SUBJECT: Cat Rock Tank
Reply to Attorney Dan Hill Letters

Cat Rock Construction Layout for Pre-Stressed Concrete Tank at Alternative 1

**Re: Cat Rock Hill Water Tank – Design Change
Bradford Road
Weston, Massachusetts**

Figure 1

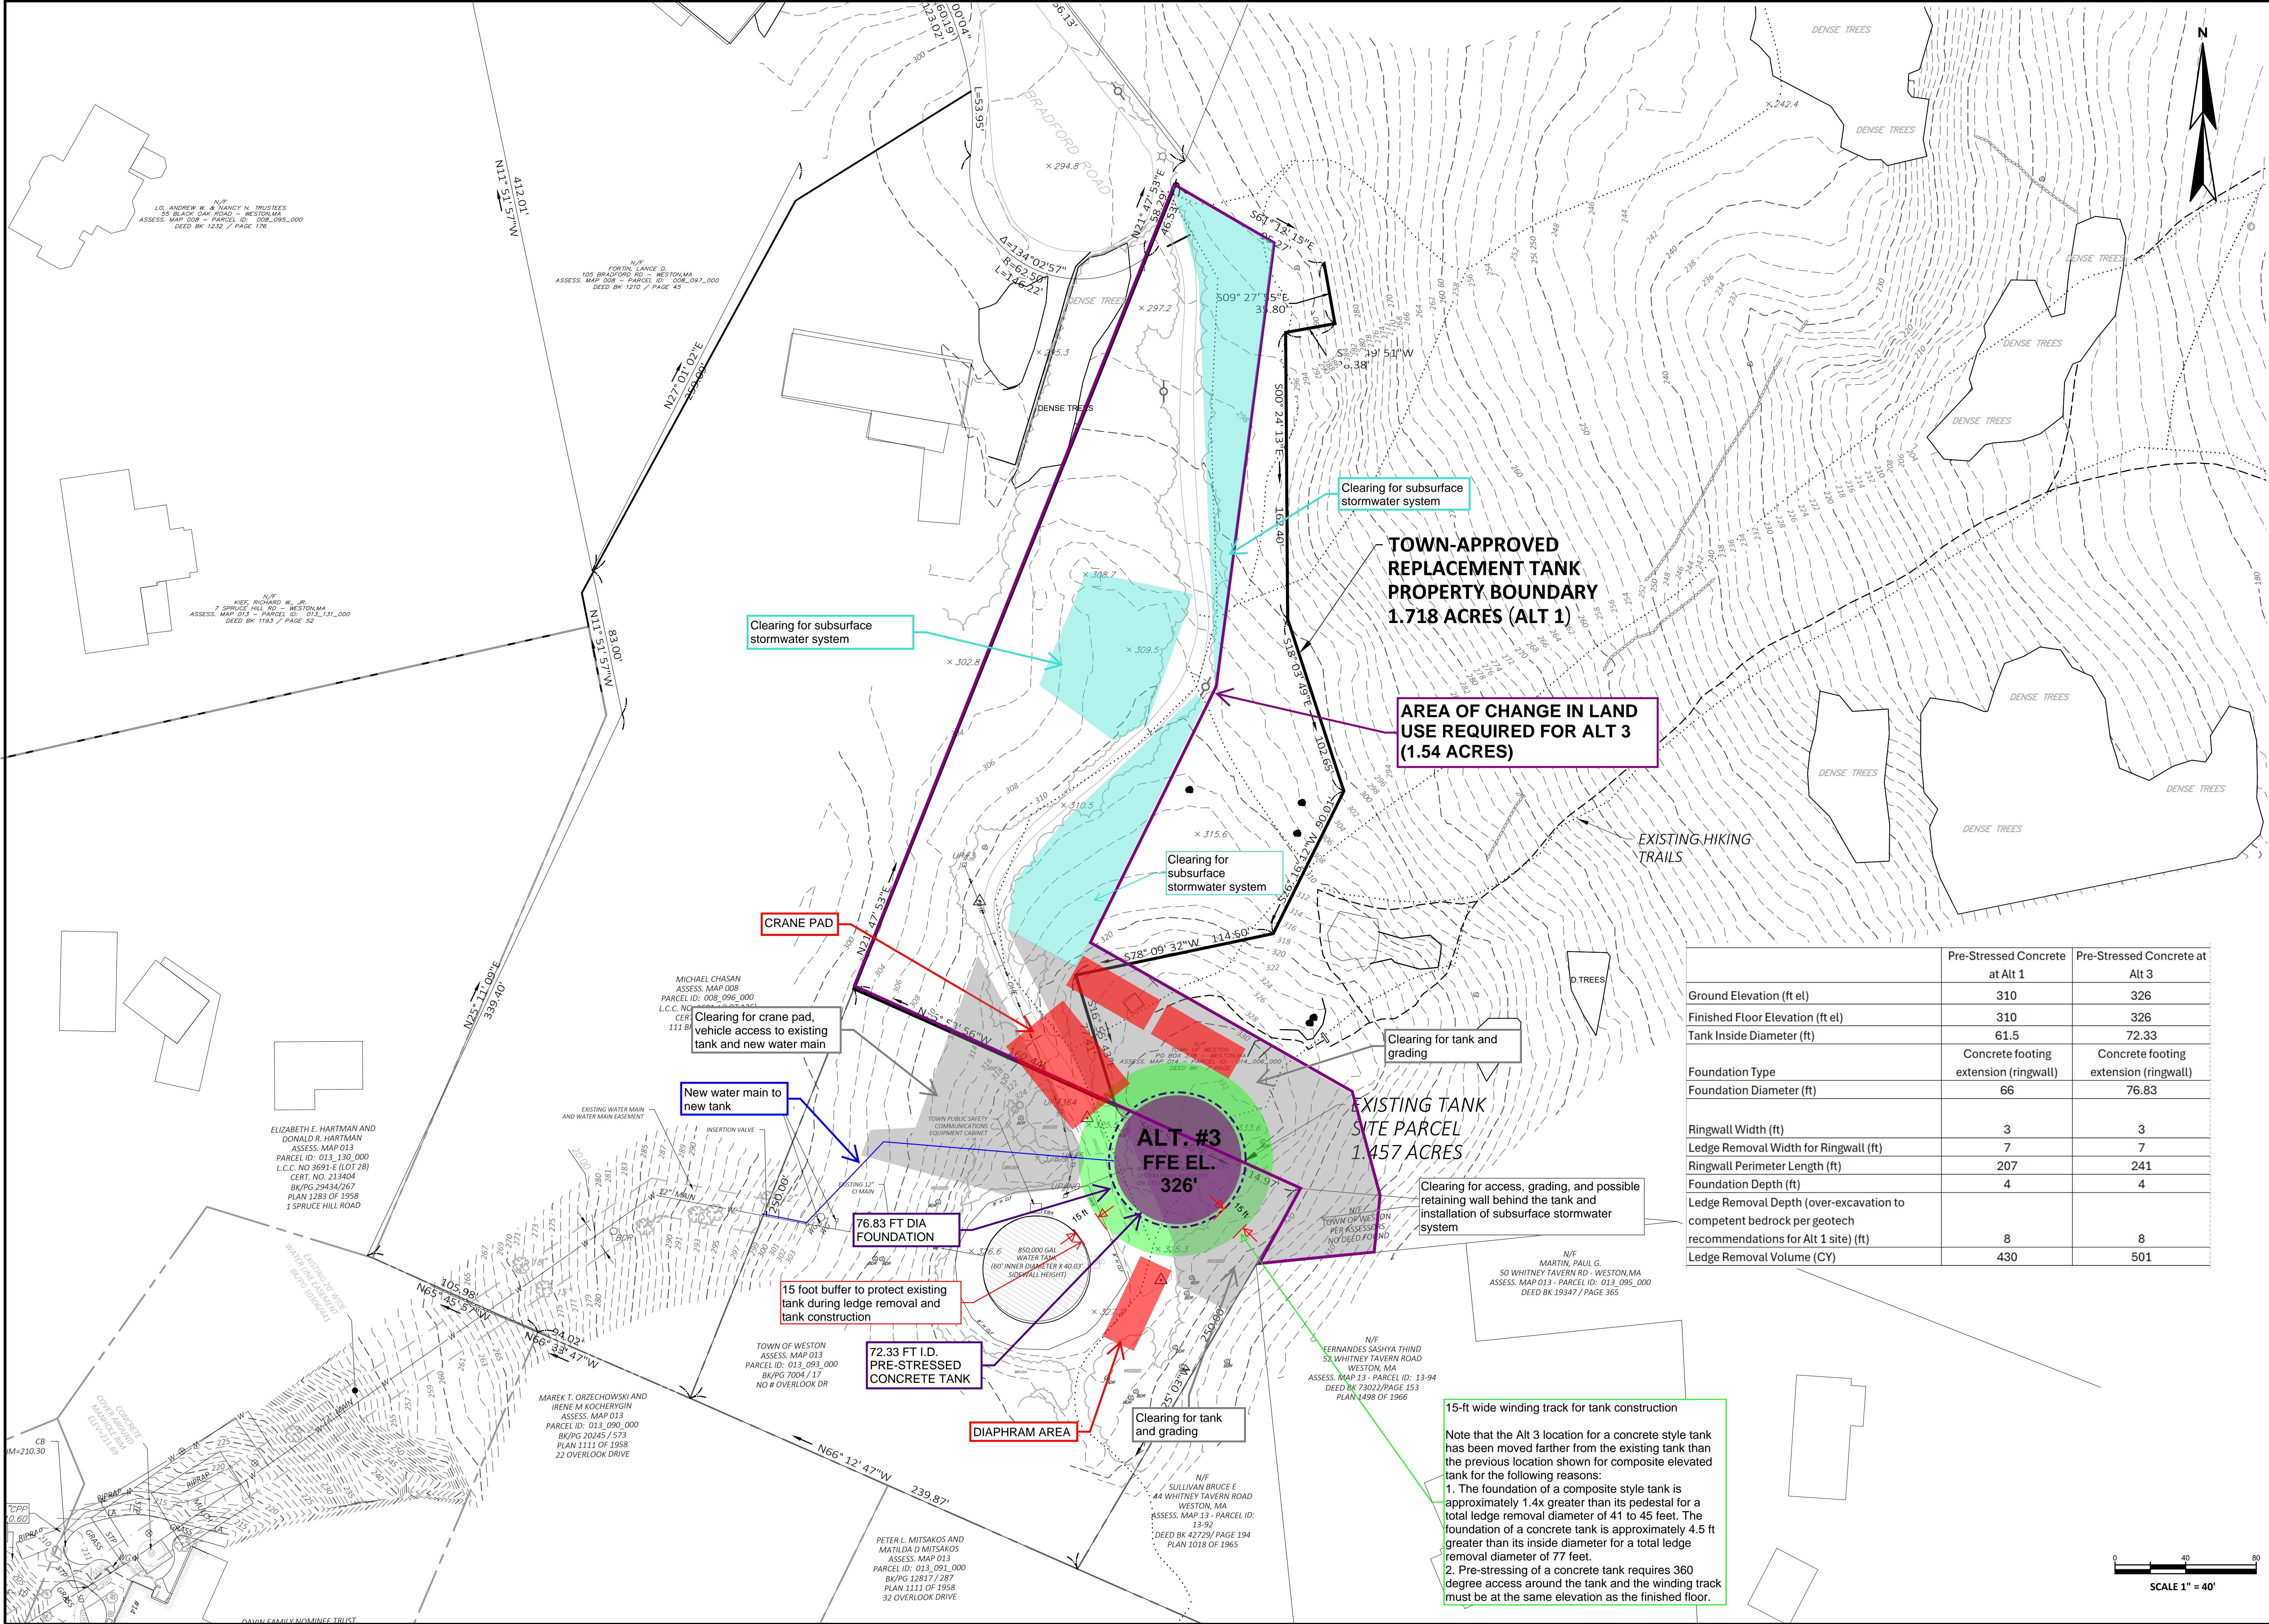
The increase in diameter and clear space needed around the floor of a concrete tank for construction will further limit the available laydown area needed to form and cast wall and dome panels. This will restrict and perhaps preclude concrete tank manufacturers from casting panels on the existing site while leaving space for a crane to move around the tank to lift panels. The limited space to the southeast of the existing tank would not be accessible by a crane, leaving the Cat Rock lookout as the only area to cast panels near the tank location (see attached Figure).

The existing site is even more challenging for the construction of a precast concrete tank because of the need to cast wall and dome panels directly adjacent to and around the tank. As noted above, we do not think this is possible without expansion of the site (onto private property) and/or removal of even more of the Cat Rock lookout (see attached Figure).

Figure 1 – Water Main Extension to Proposed Alt. 1 Location

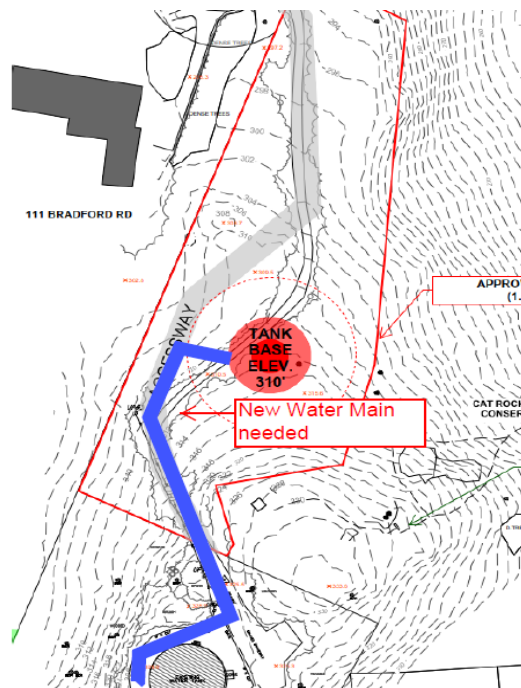
Tetra Tech’s letter includes a Figure depicting their interpretation of where the proposed location of the new water main would be and the additional tree removal this route will require and they note that the construction of this connection will require a shutdown of the tank(s).

Article 97 impacts: The re-design will require new water main extending from the existing tank location through article 97 protected land to the new water tank location. See **Figure 1, below**. This extra water main and its additional impact on article 97 land was specifically cited by WP as a disadvantage of siting the new tank near the existing tank due to the added distance from the proposed Bradford Road water main. The re-design would also likely require a tank shutdown to connect the existing water mains to the new tank. The proposed re-design would essentially flip what was a positive outcome to a negative outcome in a category assigned the highest priority.

This alignment is not what we have proposed. Our design routes the new main through what is already a cleared gravel pathway to the existing sampling station and hydrant and therefore will require no additional tree removal. In addition, a shutdown is required under any scenario being considered and has no bearing on the sitting or analysis.
